Access Compliance Report

Public Rights-of-Way

(Curb Ramps)

Intersection ID: 19121		Main Street: MILLBURY_CT		Cross Street: RAMA_RD		Location: NE			
ADA ID: 719B18D26FF4		Ramp Type: PerpDiag		Initial Pass/Fail: Fail		Overall Compliance: No		Severity Score: 25	
Codes/Mitigation Info/Possible Solution					Field Measurements/Component Compliance

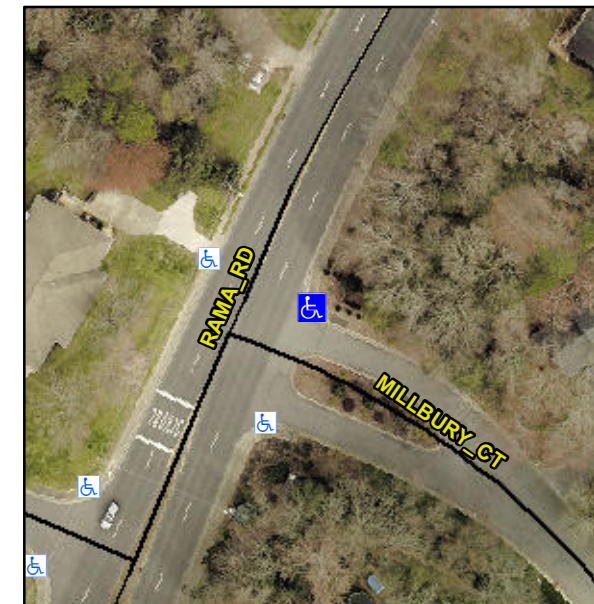
Not Found, R304.5.3

Compliance	Description	Data	Compliance	Description	Data
N/A	Ramp Length (in)	60.5	Yes	Ramp Slope (%)	7.3
Yes	Ramp Width (in)	48.0	No	Ramp XSlope (%)	7.6
N/A	Flare Type LT	N/A	N/A	Flare Type RT	N/A
N/A	Flare Slope LT (%)	N/A	N/A	Flare Slope RT (%)	N/A
N/A	Flare Traversable LT?	N/A	N/A	Flare Traversable RT?	N/A
N/A	Landing Length (in)	N/A	N/A	DWS Provided?	N/A
N/A	Landing Width (in)	N/A	N/A	DWS Contrast?	N/A
N/A	Landing Slope (%)	N/A	N/A	DWS Length (in)	N/A
N/A	Landing X Slope (%)	N/A	N/A	DWS Full Width?	N/A
N/A	Landing Curb? (Y/N)	N/A	N/A	DWS Offset (in)	N/A
N/A	Shared Landing?	N/A			
N/A	Gutter Ponding?	N/A	N/A	Gutter Slope (%)	N/A
N/A	Gutter Lip Ht (in)	N/A	N/A	Gutter X Slope (%)	N/A
N/A	Painted X Walk1?	No	N/A	Painted X Walk2?	No
	X Walk 1 Direction	To NW		X Walk 2 Direction	To SW
N/A	X Walk 1 Width (in)	N/A	N/A	X Walk 2 Width (in)	N/A
	X Walk 1 Slope (%)	4.7		X Walk 2 Slope (%)	2.2
	X Walk 1 X Slope (%)	2.3		X Walk 2 X Slope (%)	5.1

Remove & Replace Curb Ramp With Two New Directional Ramps or Equivalent.
